Item Name: 205 Skidtube bent detail

| DRAWING NO. D2580 | TITLE 205 SKIDTUBE ASSEMBLY | REV. D | DART AEROSPACE LTD ENGINEERING ORDER | | D.E.O. NO. D2580-D-1 | SHEET NO. SHEET 1 OF 1 | SCALE NTS |

PURPOSE:

CHANGE ALL WELDED CROSSBOLT SPACERS TO SWAGED SPACERS

SECTION D-D & SECTION H-H ARE AMENDED AS FOLLOWS:

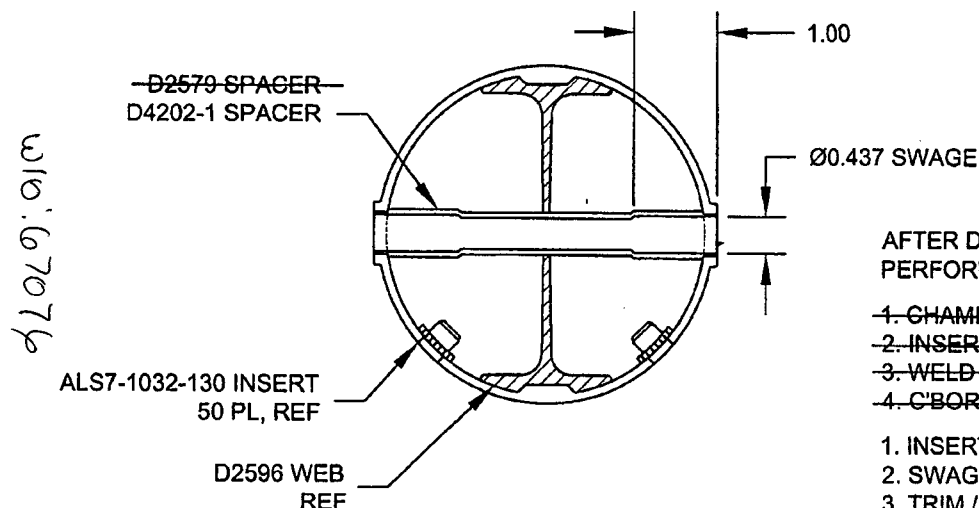
AFTER DRILLING AND BENDING ASSEMBLY
PERFORM THE FOLLOWING FOR Ø0.508 HOLES ONLY:

- ~~1. CHAMFER HOLE 0.050 X 45°~~
- ~~2. INSERT D2579 SPACER (20 PLACES)~~
- ~~3. WELD INTO PLACE AND GRIND FLUSH~~
- ~~4. C-BORE D2579 SPACER TO Ø0.437 X 1.00 DEEP~~

1. INSERT D4202-1 SPACER, 20 PL (-041) OR 24 PL (-045)
2. SWAGE TO Ø0.437 X 1.00 DEEP PER QSI 002
3. TRIM / GRIND FLUSH PER QSI 002
